FINAL STUDY PLAN

BAR MILLS HYDROELECTRIC PROJECT

FERC No. 2194

RESPONSE TO DRAFT STUDY PLAN COMMENTS

Figure 2 Bar Mills Project Features

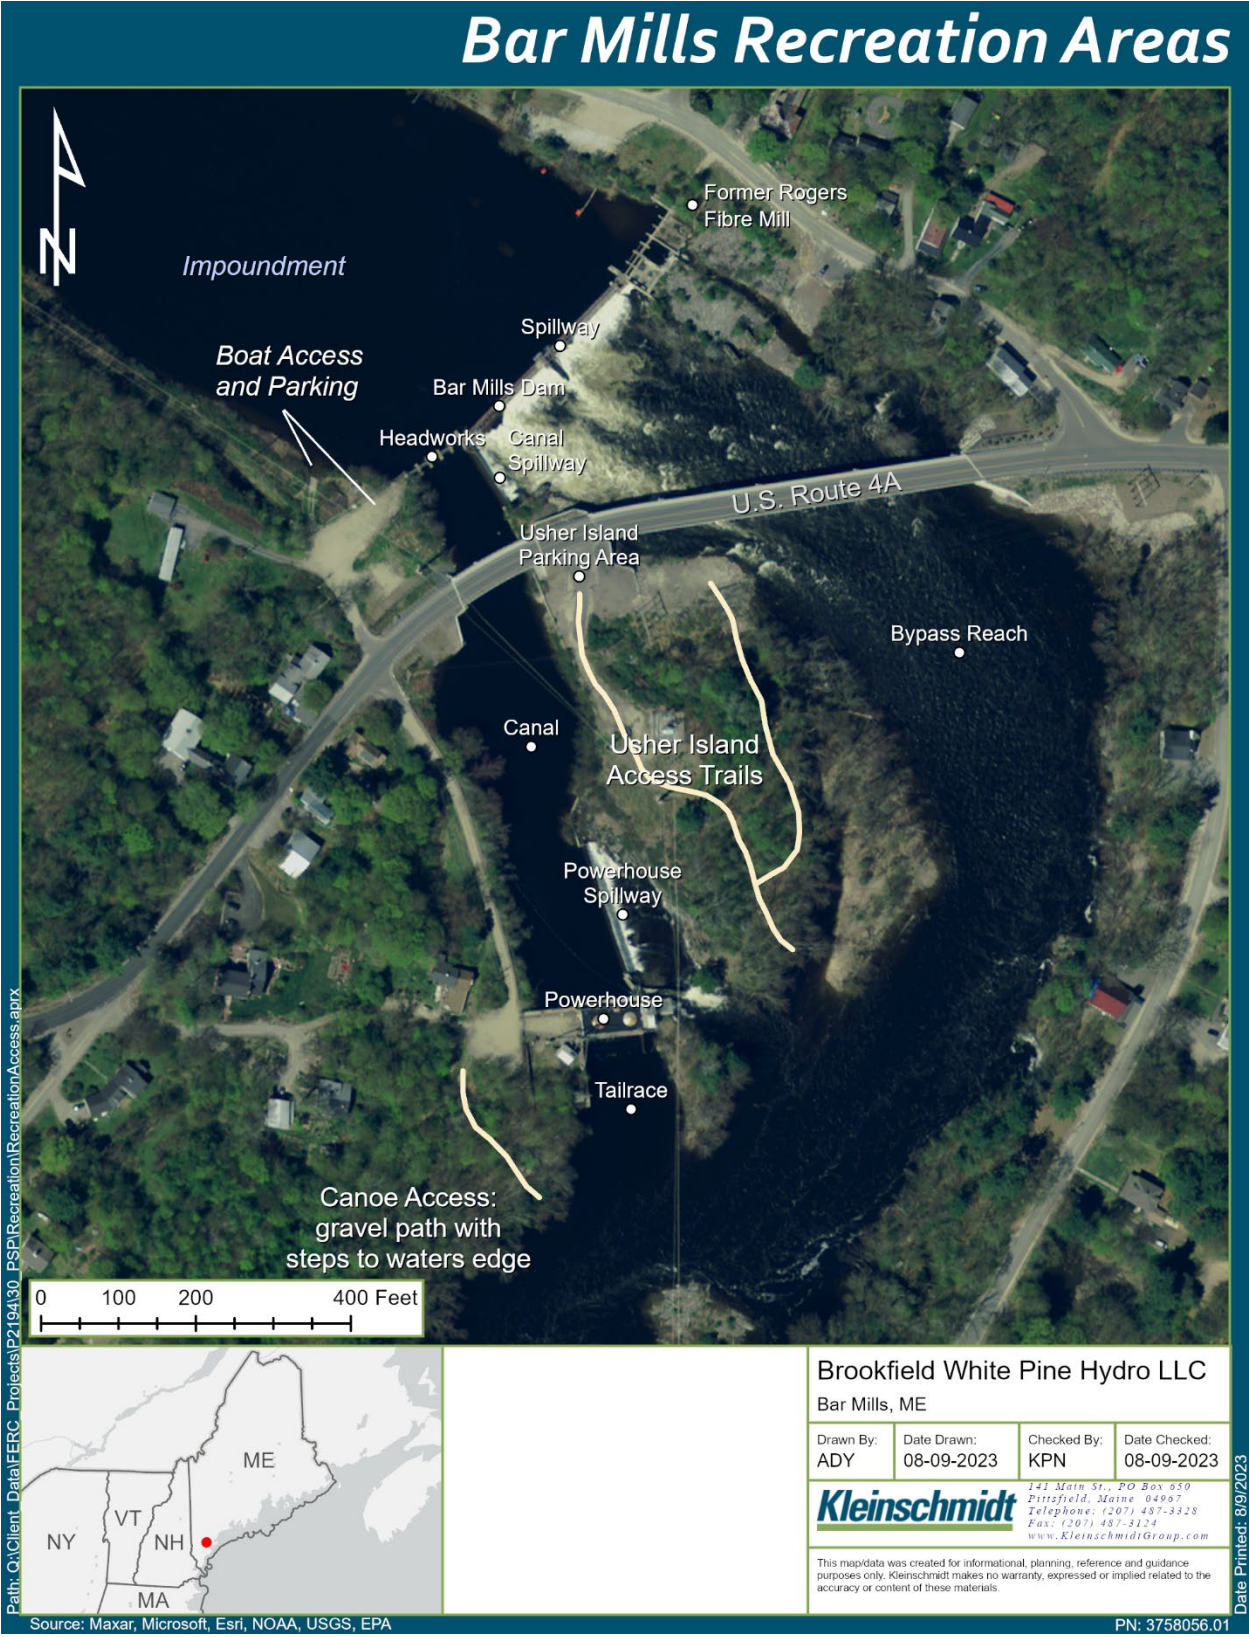
Kyle Olcott	Maine Department of Environmental Protection	Biological Monitoring		Please add the location of the former Rogers Fibre Mill remediation site to Figure 2.	The study plan has been revised to include macroinvertebrate sampling.
Kyle Olcott	Maine Department of Environmental Protection	General Comments		In Section 5.3, please add that you will consult with MDEP Division of Remediation if the scope of work changes to involve soil disturbance at the former Rogers Fibre Mill site.	The study plan has been revised to incorporate this comment.
Kyle Olcott	Maine Department of Environmental Protection	General Comments			The study plan has been revised to incorporate this comment.
June 14, 2023 Town Meeting Questions					
Bart Sugman	Town of Hollis	Sediment	Pleasant Pond and Skleton Pond	Is sediment going to wash down to Pleasant Point and Skelton Pond? What will the effect of the removal have on the Skleton Pond level? Will the water level still be going up and down 3 feet a day? Are there any potential buyers that might want to keep the dam? Seems like a big infrastructure to lose.	Part of study is to evaluate what the sediment will do with modeling, some sediment that has collected at the dam will be excavated as part of the removal. There will be no effect on Skelton pond water level, water level associated with Skelton operations does not change as a result of the Bar Mills dam partial removal.

- Addition of American eel to the list of migratory species
- Addition of depth and velocity graphics for the 50% flow exceedance
- Addition of Stony Brook to the Zone of Passage Field Assessment
- Revisions to Table 1 (Maine Water Quality Standards for Select Parameters for Class A Waters)
- Addition of macroinvertebrate sampling
- Addition of the former Rogers Fibre Mill to Figure 2
- Revision of Section 5.3 for additional MDEP consultations, if necessary

Figure 3 Water Depths at 762 cfs

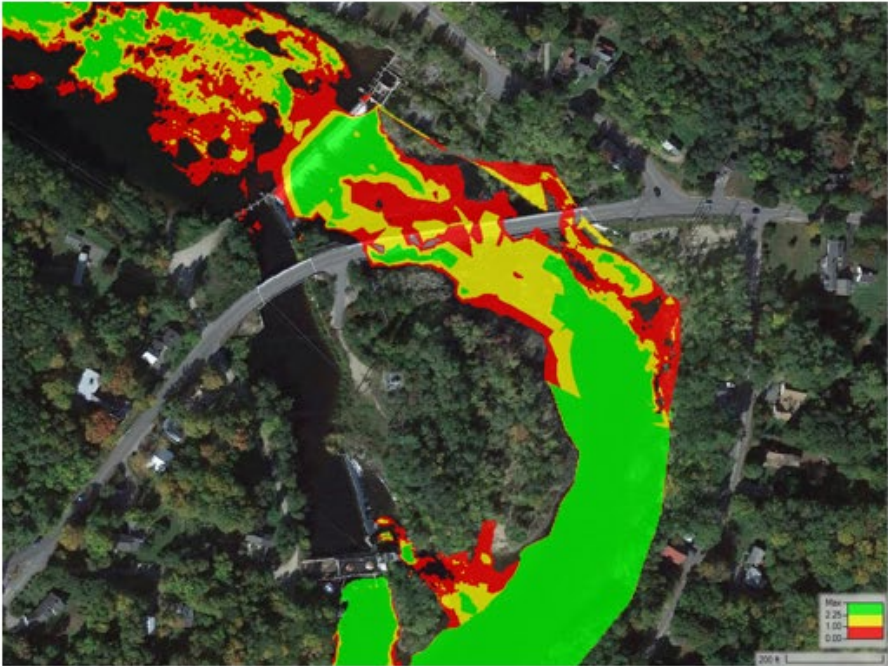
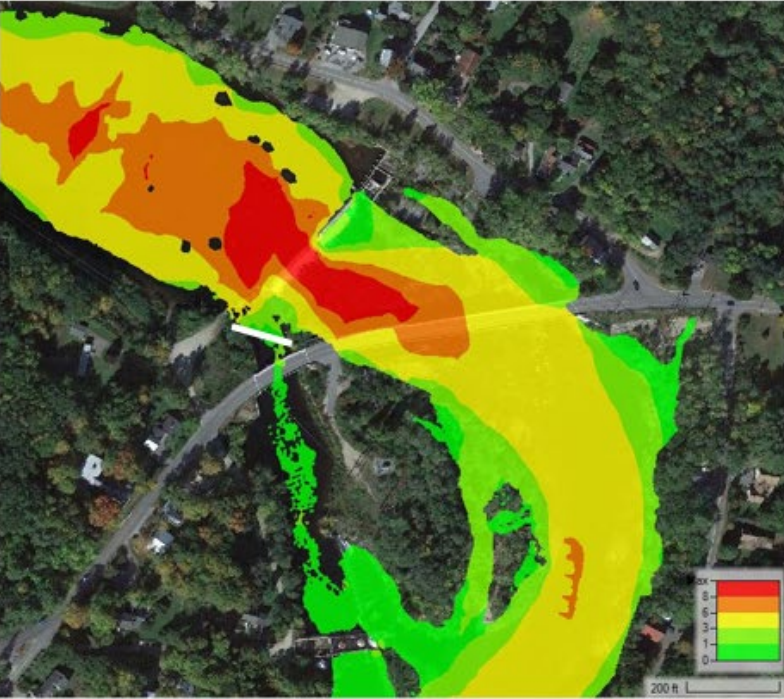
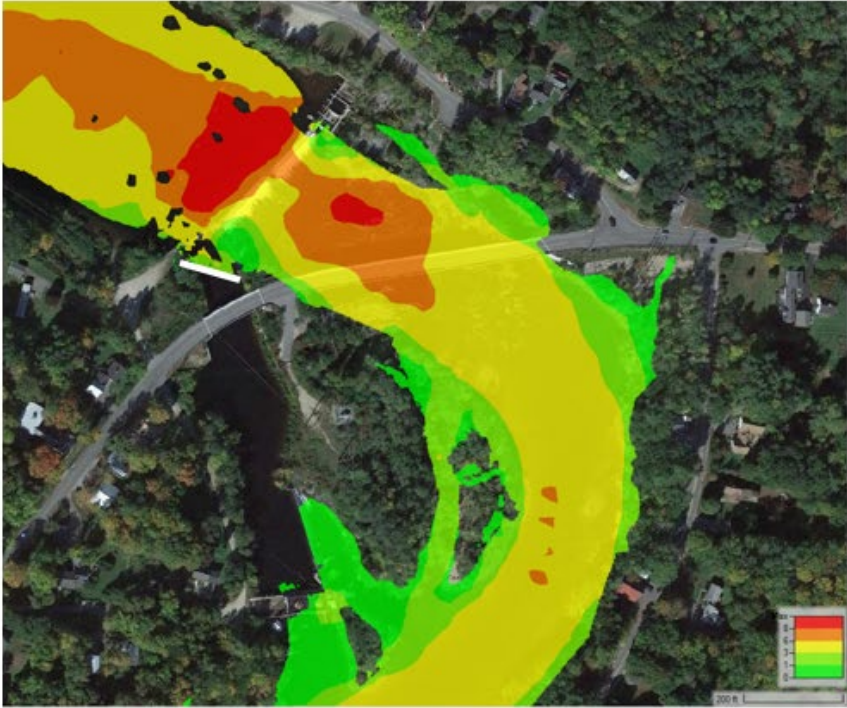
Casey Clark	Maine Department of Marine Resources	General Comment	Page 35-36 (pdf page 39-40): Partial Removal and Full Removal Figures	95%, 50%, and 5% exceedance flow scenarios were shared for both depth and velocity for the breach option, but only the 5% velocity and 95% depth were shown for the full removal. MDMR requests BWPH share additional flow scenarios for the velocity and depth for the full removal alternative. A partial removal leaves a structure that will no longer fulfill its intended activity nor be consistent with the new conditions, use, and character of the river.	Depth and velocity graphics for all flow scenarios for full removal will be included in the Study Report.
Casey Clark	Maine Department of Marine Resources	General Comment	Partial Breach		The remaining structures will serve alternate intended uses. BWPH's proposal does not include removal of the powerhouse, therefore Phase I testing of the powerhouse or study is not necessary. However, BWPH has already initiated removal of unneeded oil and chemicals from the powerhouse. Testing of sediments immediately upstream of the dam, timber crib dam, headworks and within the canal are proposed. Testing of the spillway itself is unnecessary as it is structural concrete, not sediment.
